## BID PACKAGE #2 ADDENDUM #01

**DATE:** December 5, 2024      **PROJECT NO:** 24-038  
**TO:** Gramoll Construction      **PROJECT:** DTC Welding Technology Bldg  
155 S 750 W St  
North Salt Lake, Utah 84054

The original specifications and drawings, labeled “Bid Package #2”, dated November 1, 2024 and issued for the project referenced above are amended by the following content and form a part of the Contract Documents.

ARCHITECTURAL  
SITE DETAILS  
**AS110.2**

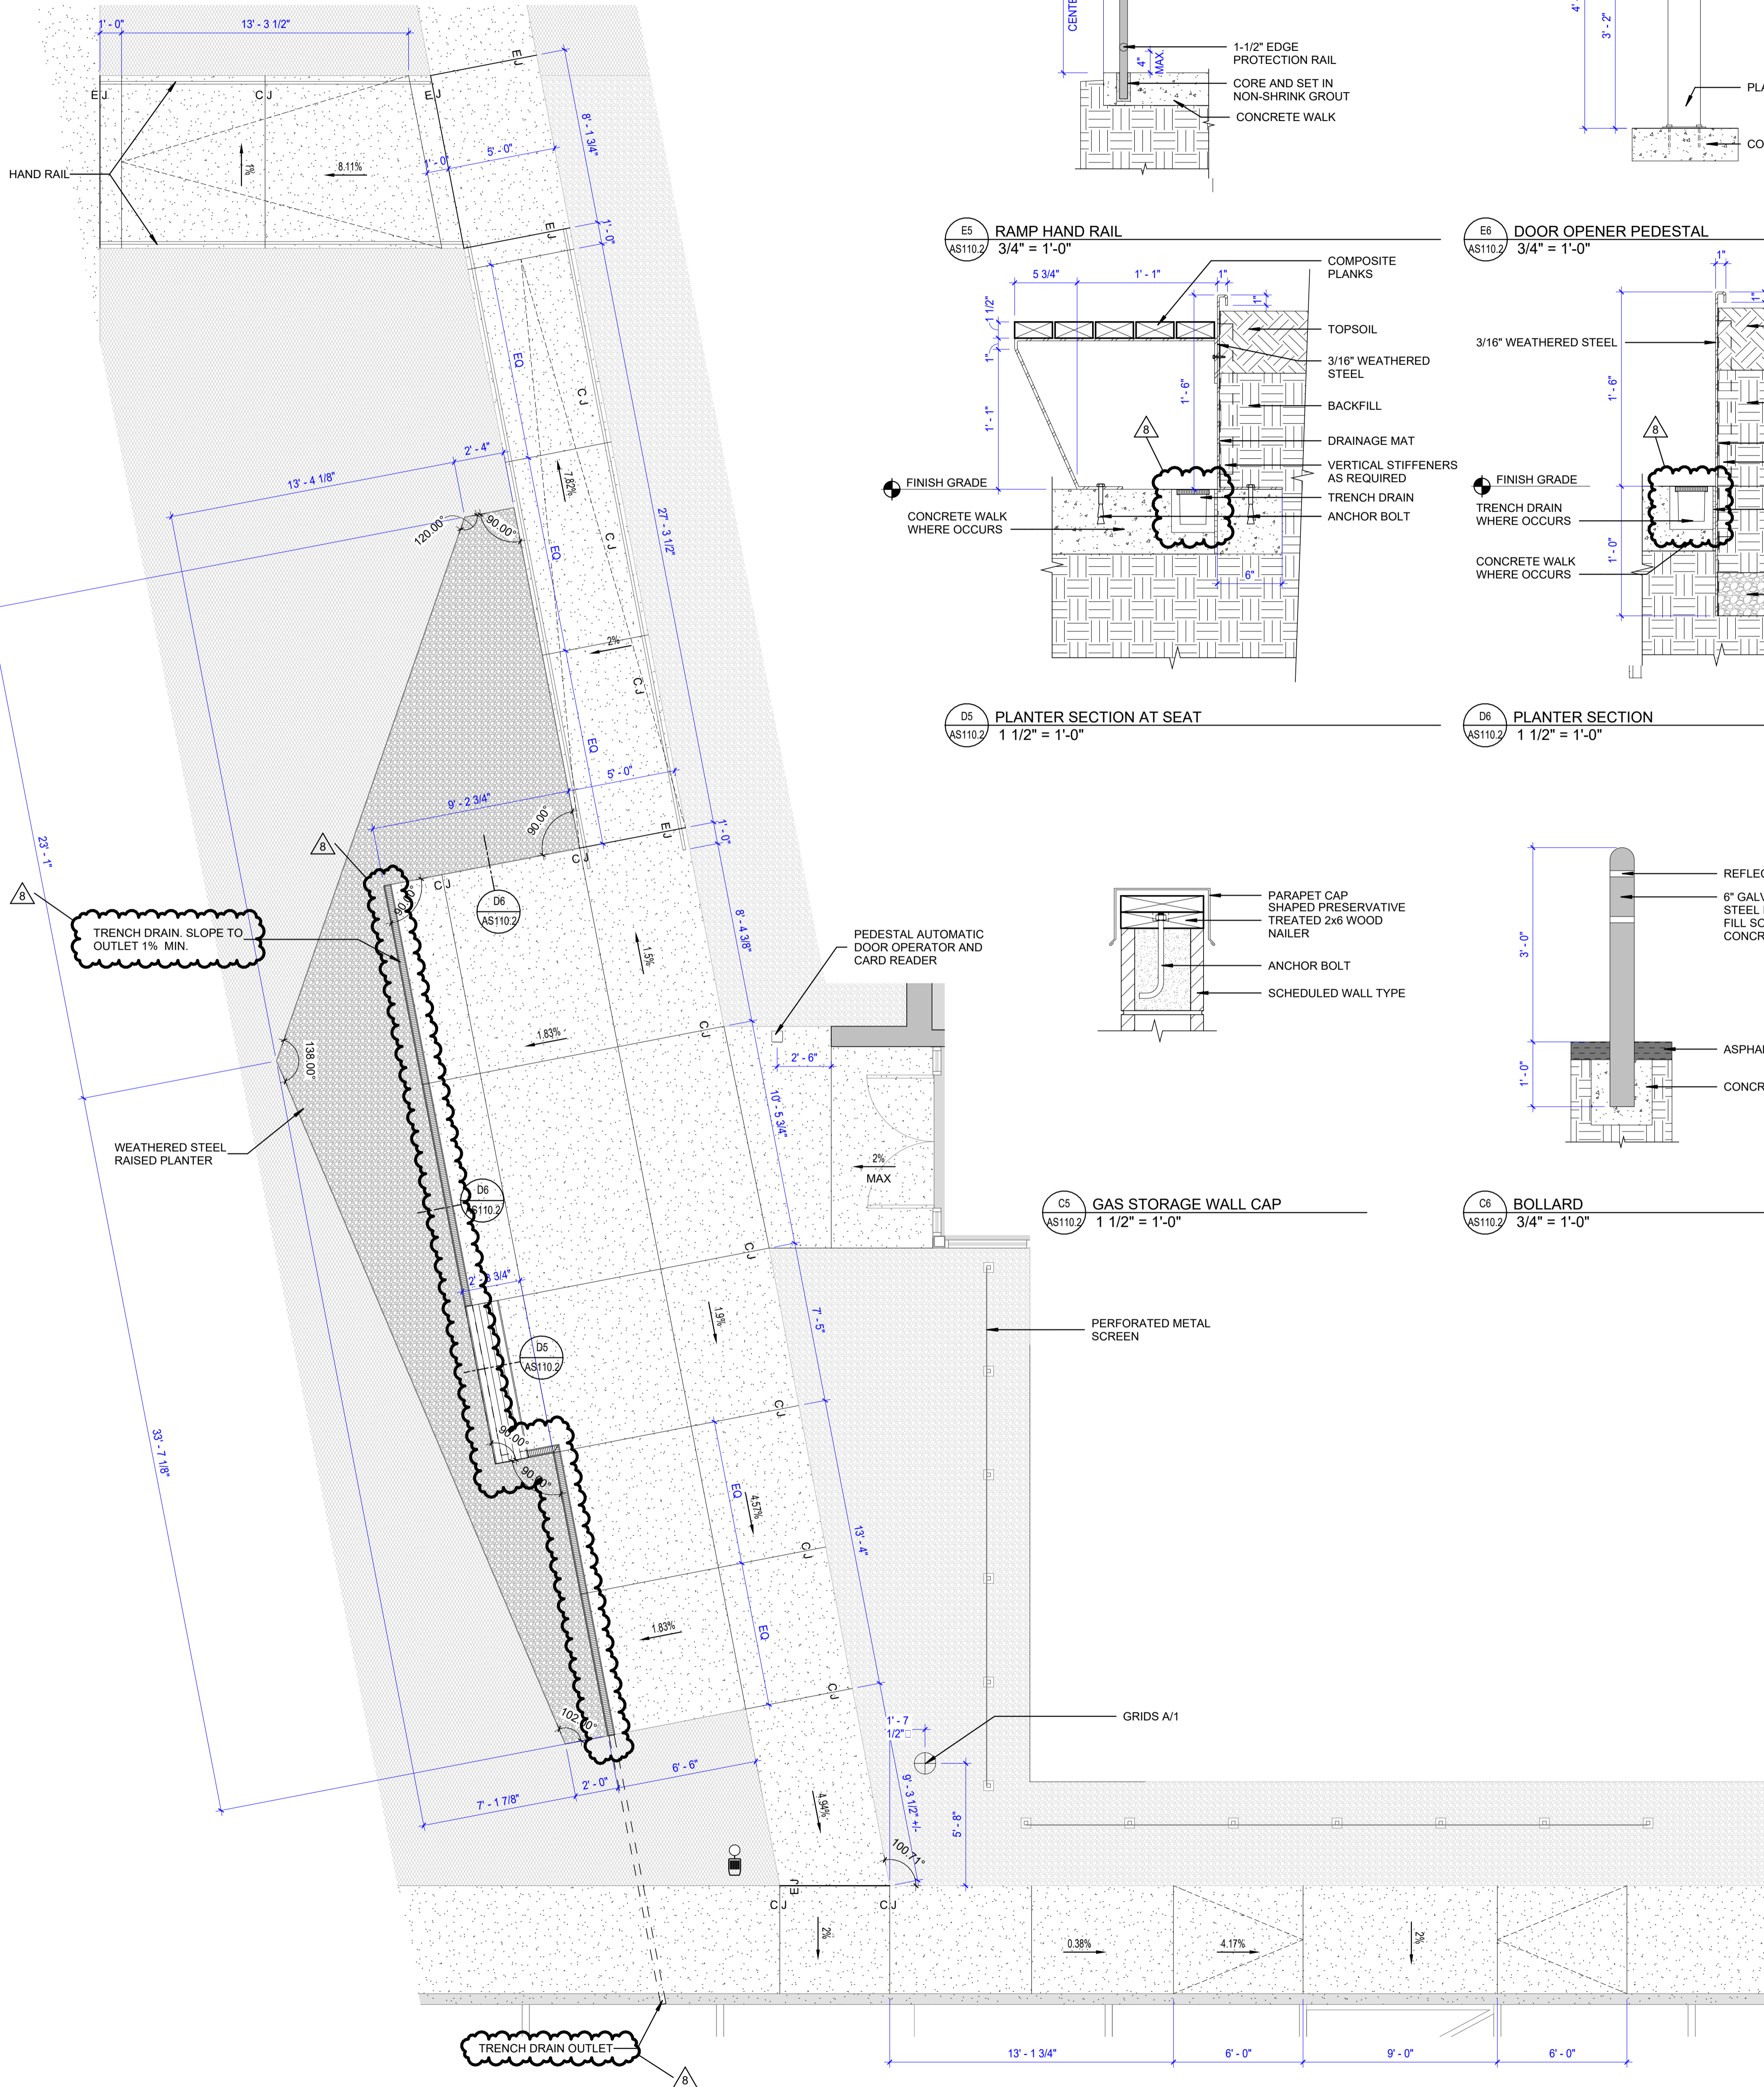
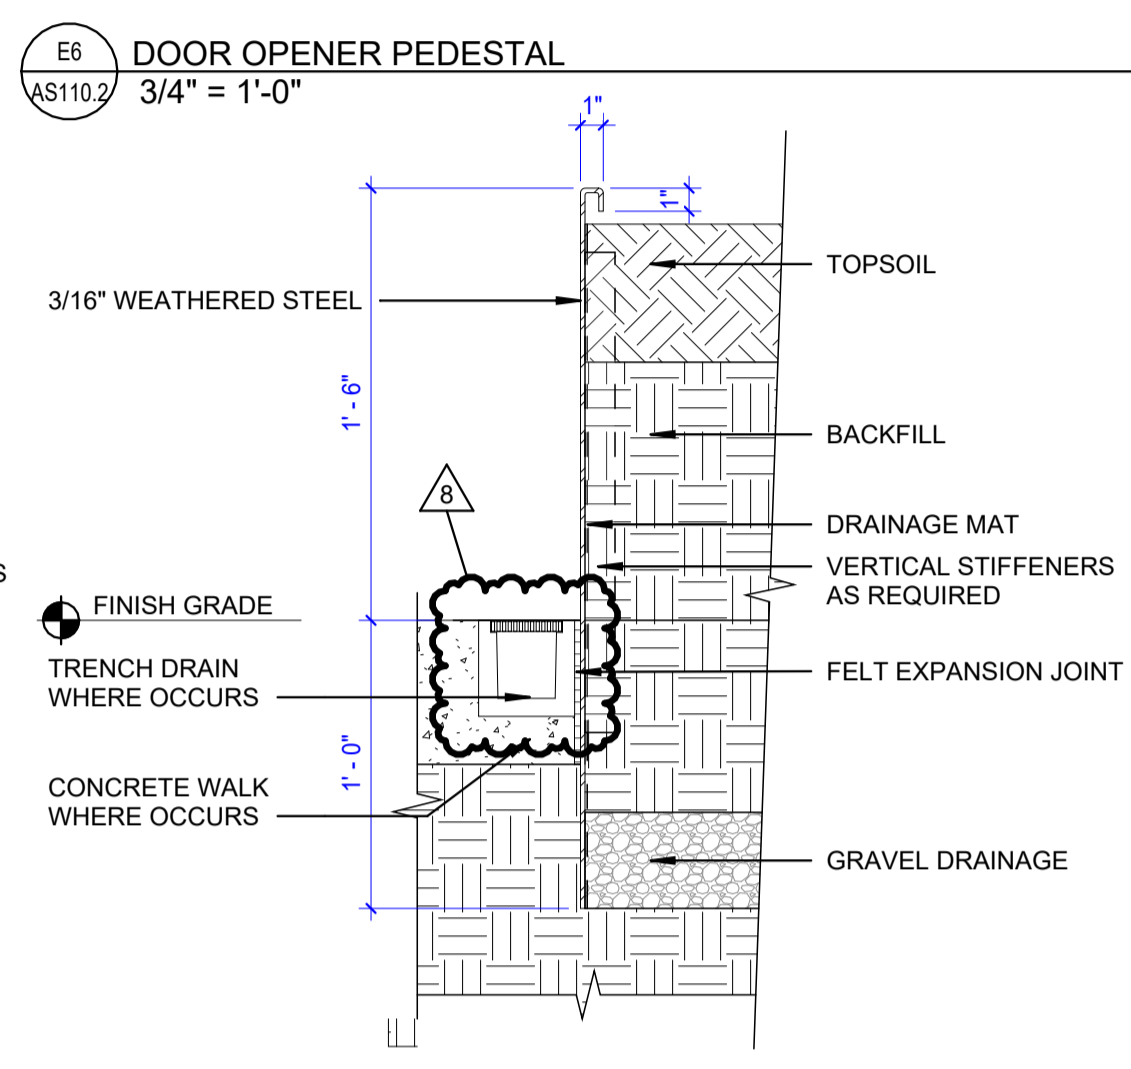
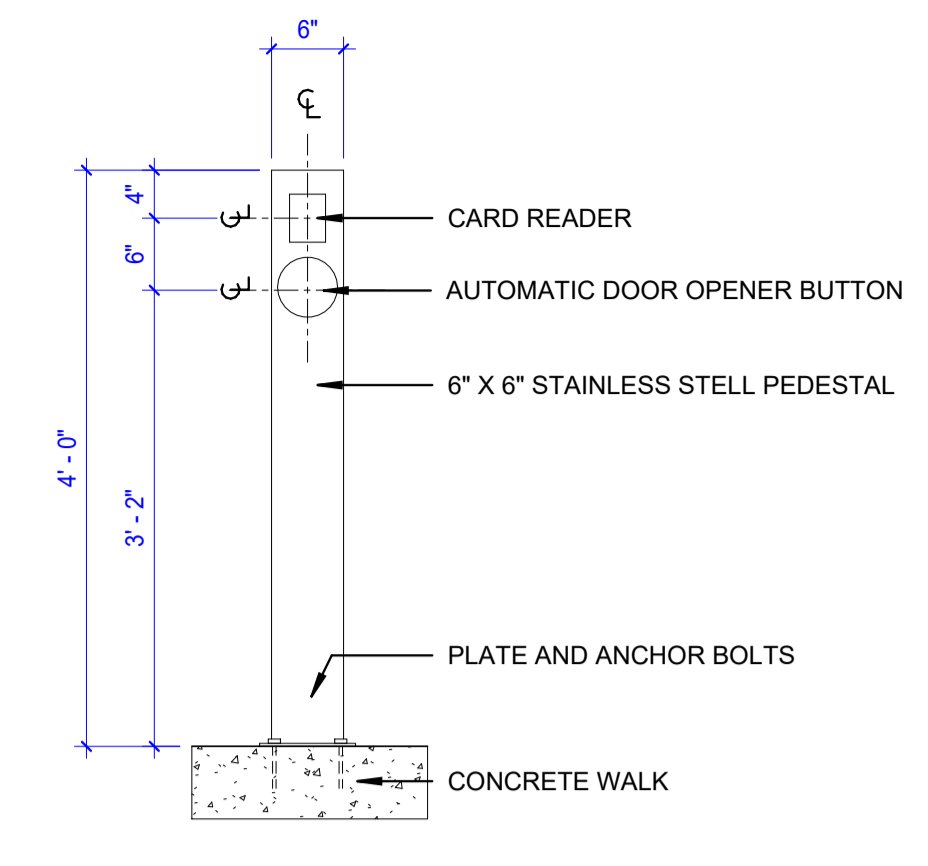
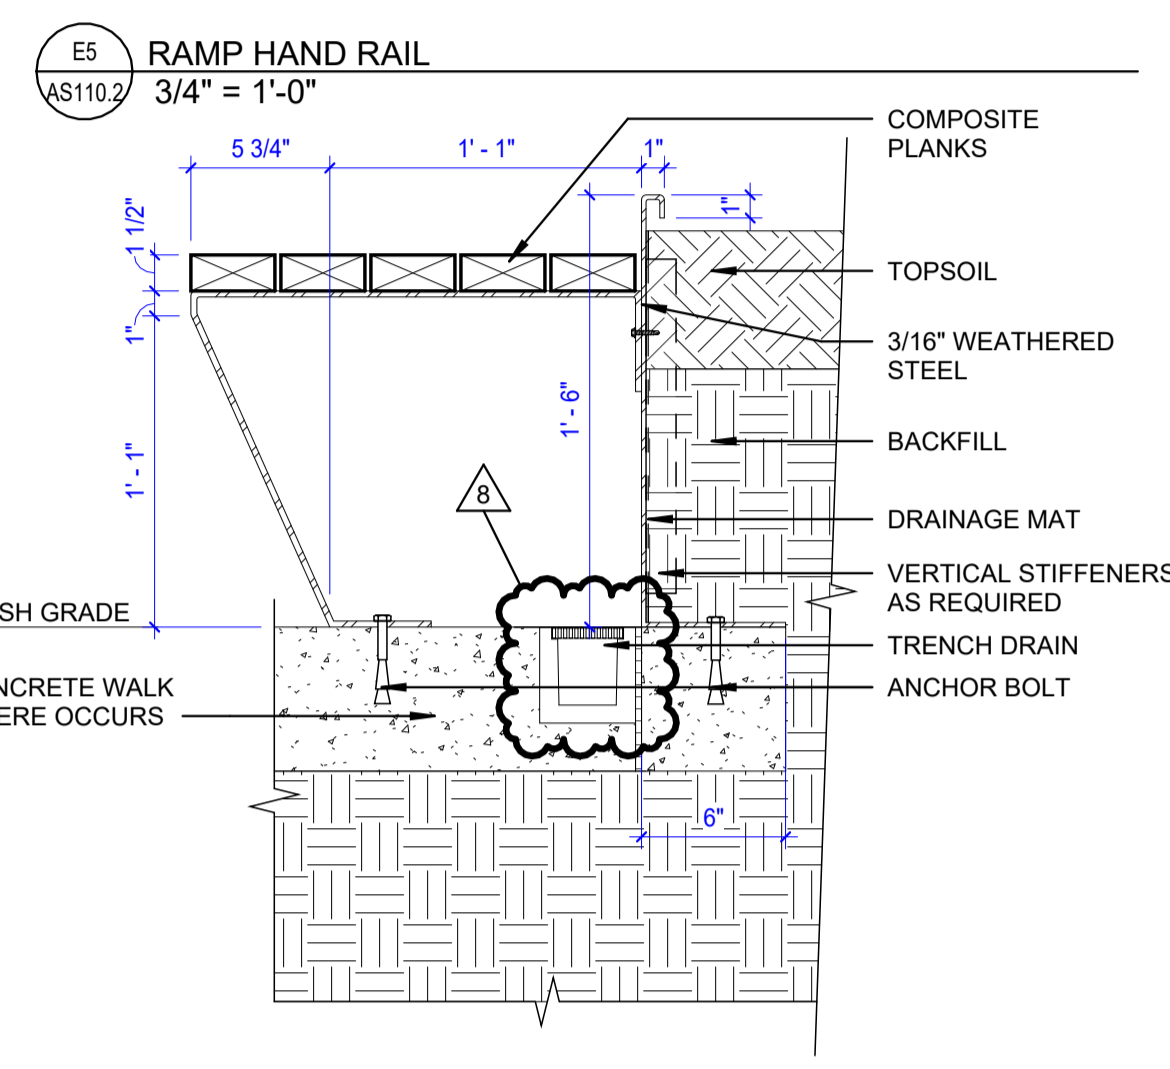
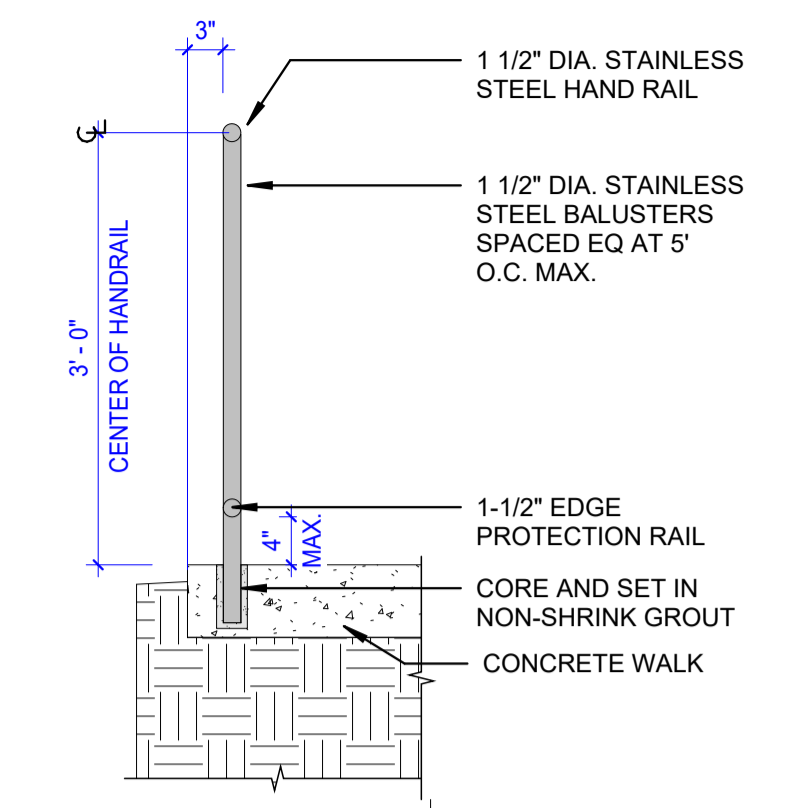
- a. AS101.2
  - i. Revised drawings to show new ships ladder location, chainlink fence & gate.
- b. AS110.2
  - i. Added trench drain across lower end of sidewalk slope at entry plaza.
- c. AE101.2
  - i. Revised ships ladder location.
- d. AE151.2
  - i. Added alternate base material for Base Finish BS1. Bidders to provide alternate pricing for this material.
- e. AE191.2
  - i. Revised ships ladder location & deleted roof hatch.
- f. AE201.2
  - i. Revised exterior elevations to show new ships ladder location & chainlink fence.
- g. AE402.2
  - i. Revised interior elevations to show revised student refresh millwork.
- h. AE525.2
  - i. Revised ships ladder details.
- i. AE530.2
  - i. Revised student refresh millwork elevation to add cabinets. Deleted countertop bracing detail.
